Subject: Transmittal of Class 1 Permit Modification Request to Remove Dome 224 from the Los Alamos National Laboratory Hazardous Waste Facility Permit

**Class 1 Permit Modification Request to Remove a
Structure from Technical Area 54, Area G, Pad 5**

**Text Changes and Replacement Figures for Permit Part 3 and Permit
Attachments A, D, E, G.8, J, and N**

Figure 27: Technical Area 54, Area G, Container Storage Units

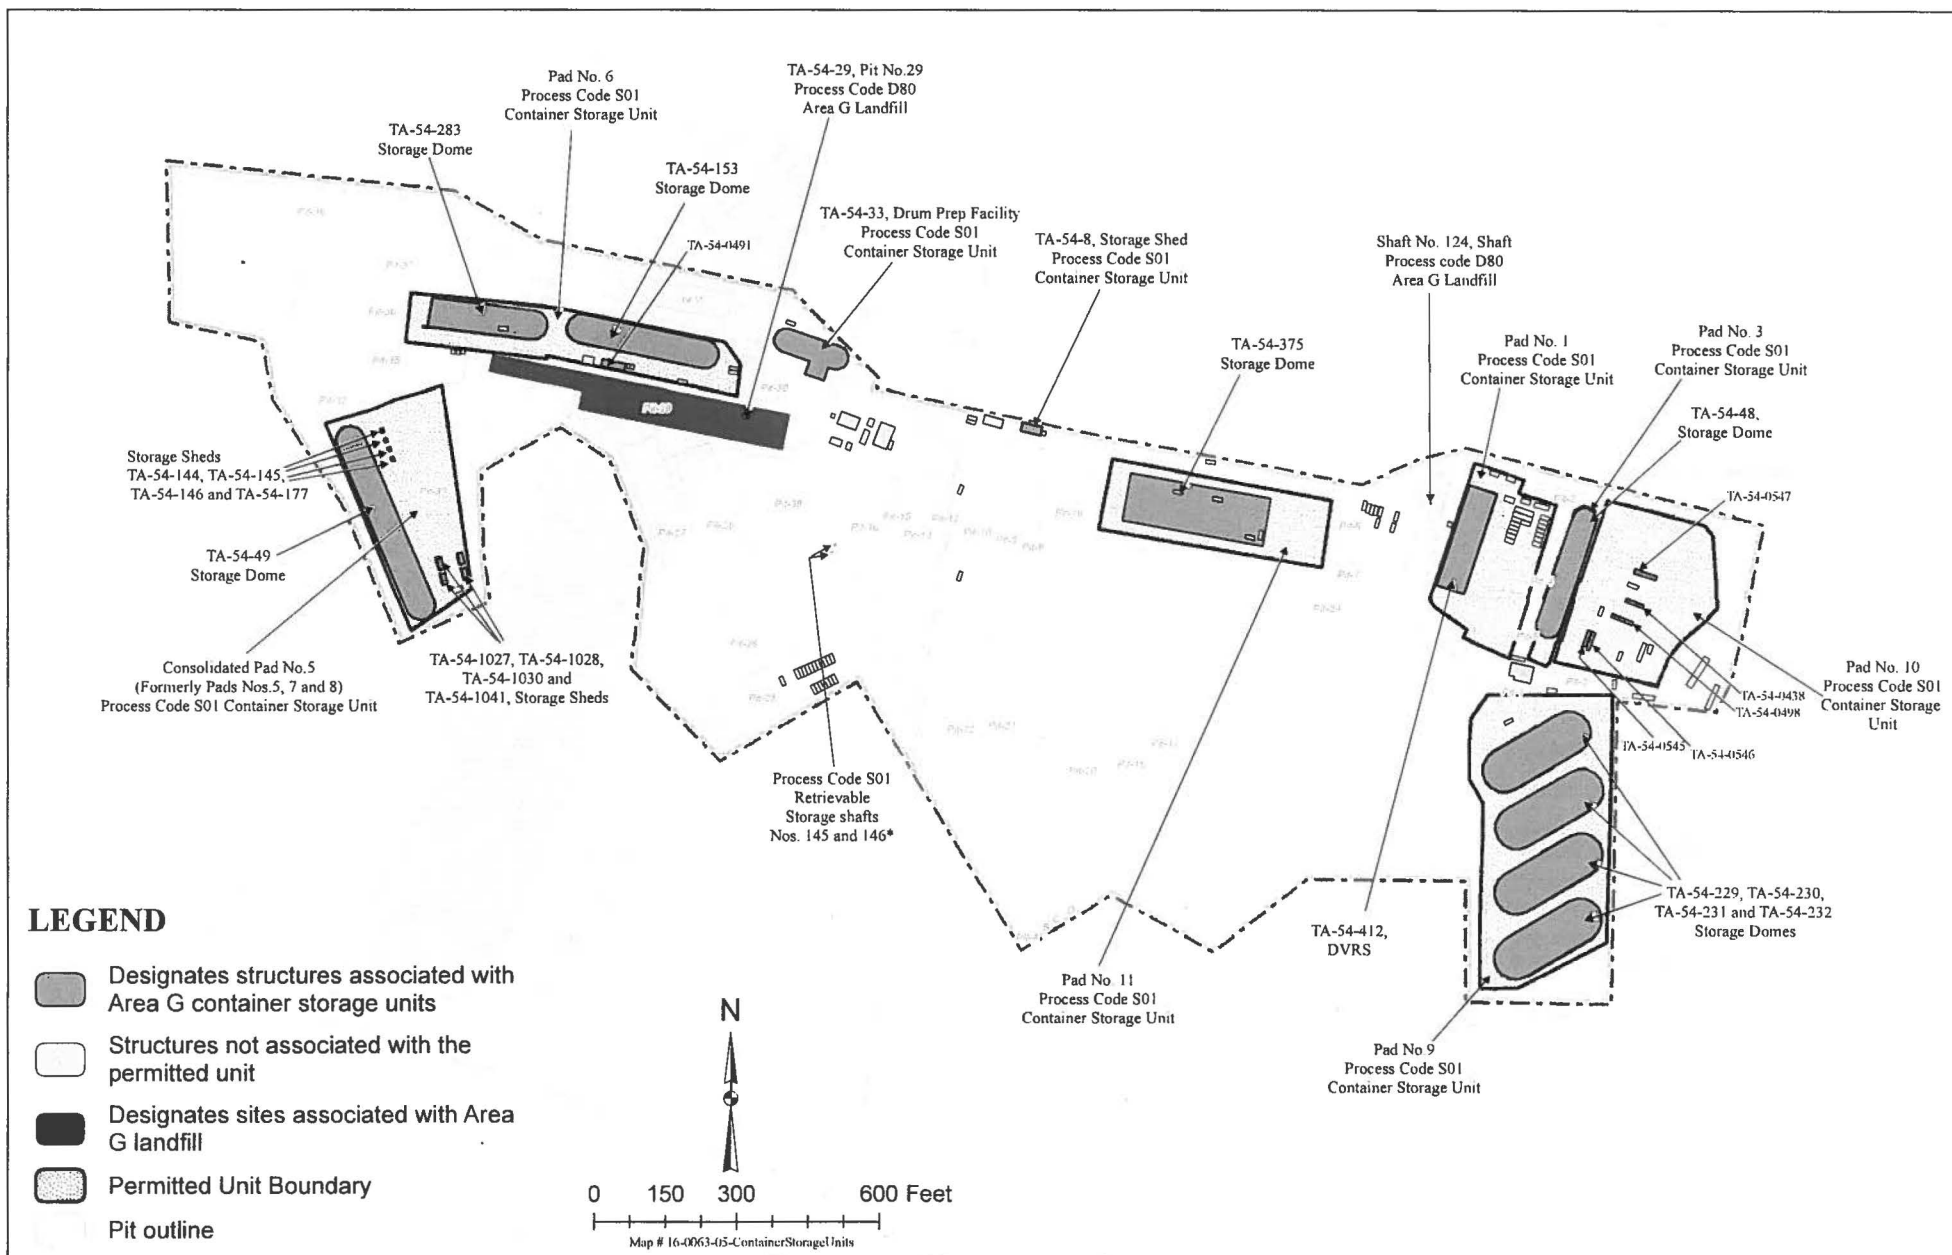
Figure 27: *Technical Area 54, Area G, Container Storage Units*, was revised to remove Dome 224. Also, Figure 32, within Attachment N was revised to remove the Dome 224 structure from the permitted unit and the title of the figure was changed to "Figure 32: Technical Area (TA)-54, Area G, Pad 5 (Dome 49 and Storage Sheds 114, 145, 146, 177, 1027, 1028, 1030, and 1041)".
